# **NIGERIAN ELECTRICITY MANAGEMENT SERVICES AGENCY (NEMSA)**

## **NEMSA INSPECTION REPORT**

**38 MEGAWATT DUAL - FUEL FIRED TURBINE INDEPENDENT POWER PLANT, KALAMBAINA ROAD, SOKOTO**

## NEMSA INSPECTION REPORT ON 38MW SOKOTO INDEPENDENT POWER PLANT

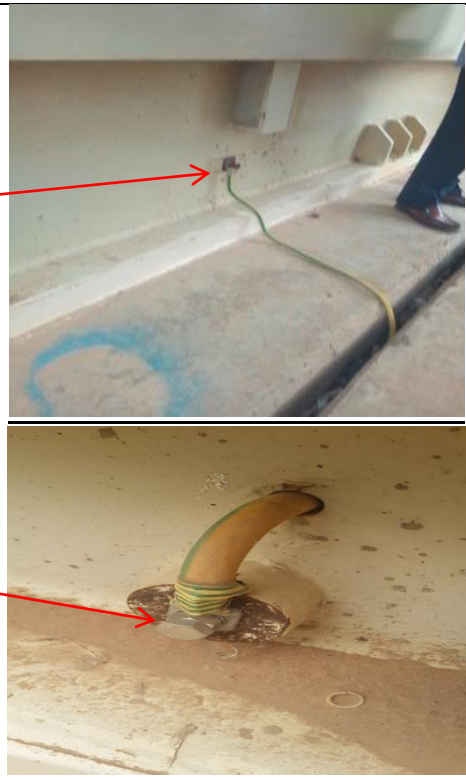
<b>S/ N</b>	<b>PROJECT DESCRIPTION</b>	<b>OBSERVATIONS</b>	<b>PICTORIAL PRESENTATION ITEMS</b>	<b>OF</b>	<b>RECOMMENDATION</b>
1a	<b>control room</b>	The control room at the Power Plant was seen without Air conditioners working thereby subjecting the panel instrumentation to high ambient temperatures.			i. Air-conditioners should be constantly provided in the control room for adequate cooling of the control panel equipment.
1b		ii. Insulation mats were not laid in front of the Power plant control panels.			ii. Insulation mats should be laid in front of the control panel in order to ensure the safety of the operator on duty.

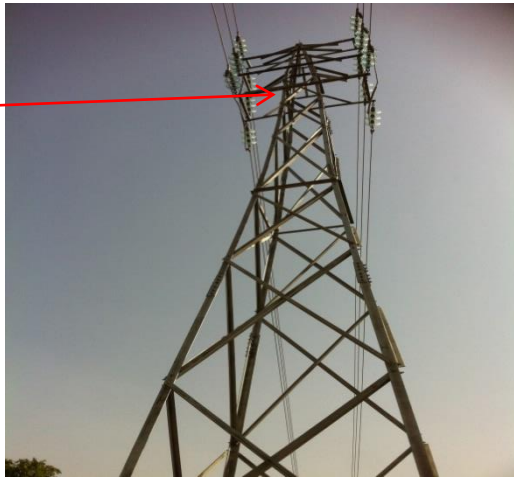
1m		xiii. Cablings and jumper terminations were still on-going at the switchyard and turbine plant ends.		xiii. The cablings and jumper terminations should be completed before the next inspection visit.
2a	<b>Switchyard battery bank</b>	<p>i. The battery bank room has no good ventilation and industrial extractor fan was not provided.</p> <p>ii. No adequate illumination in the battery bank room.</p>		<p>i. Adequate ventilation and industrial extractor fan should be provided in the battery bank room.</p> <p>ii. Adequate illumination should be provided in the battery bank room.</p>

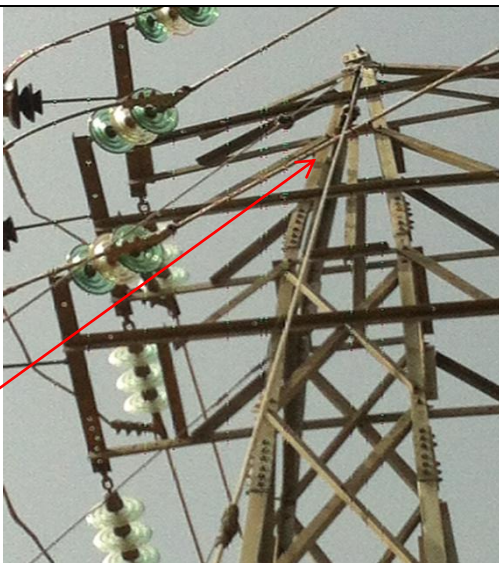
3a	<b>Switchyard Control room</b>	i. We observed that the earth conductor used at the rectifier in the control room and some gantries was undersize.		i. An earth conductor size of 70mm <sup>2</sup> should be used at the rectifier.
3b		ii. The metal door frames at the control room were not earthed.		ii. All metal door frames should be properly earthed.
3c		iii. The cable trenches at the control room were not covered with concrete slabs.		iii. All cable trenches at the control room should be well covered with concrete slabs.

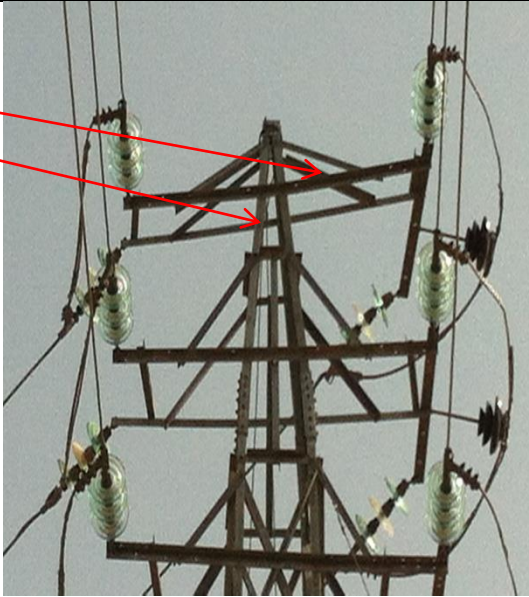
3d		iv. At the time of our visit, the contractor was seen busy fixing the lighting points at the switchyard control room.		iv. Adequate illumination is required at the switchyard control room and the switchyard itself.
3e		v. The step-up transformer oil and winding temperature indicators were not provided for in the control panel.		v. Oil and winding temperature indicators should be provided in the control panel.

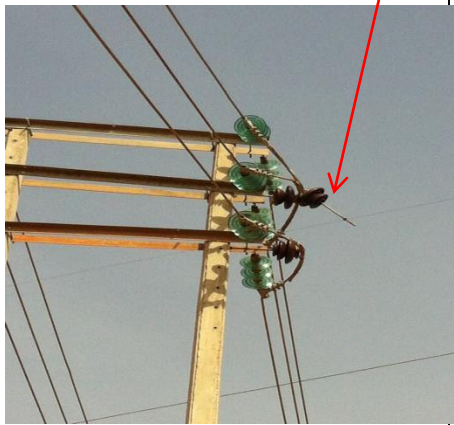
1i		xi. Legs B and C of the first tower were seen buckled.		x. The buckled legs of the first tower should be checked and amended.
1j		xi. The line crossing between the SIPP overhead line and the existing 33kV overhead line has inadequate clearance.		xii. The clearance between the SIPP and the existing 33kV overhead line should be checked and improved upon to meet minimum standard requirements.

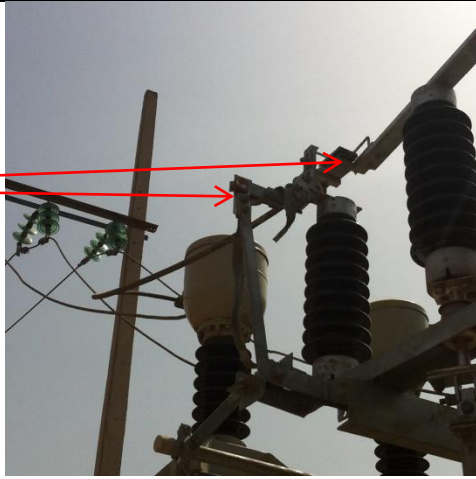
<p>xi. Many of the concrete poles were seen cracked. These are likely to cause line instability. They may break and disrupt power supply.</p>		<p>x. All cracked poles with exposed reinforcement should be replaced for stability of the line and for safety of lives and property.</p>
--	--	---	--	---

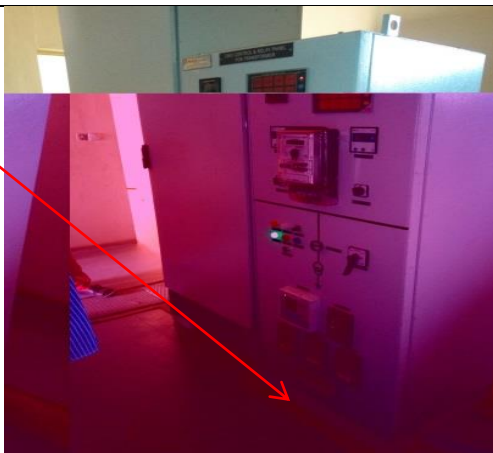
1b		<p>ii. At the connecting bay, the channel iron of the connecting bay was not earthed. Also, the jumpers between the outer Red and Blue phases were almost touching the concrete pole, as there was inadequate clearance.</p>		<p>ii. The Channel iron of the connecting bay should be earthed, while the jumpers of the outer phases that are almost touching the concrete pole should be checked and corrected.</p>
1c		<p>iii. There was no lightning arrestor at the connecting bay of the incoming SIPP 33kV feeder lines to the TCN substation. Also, all the gantry supports for the</p>		<p>iii. Lightning arrestor should be provided at the connecting bay, while the legs of all gantries should be earthed.</p>
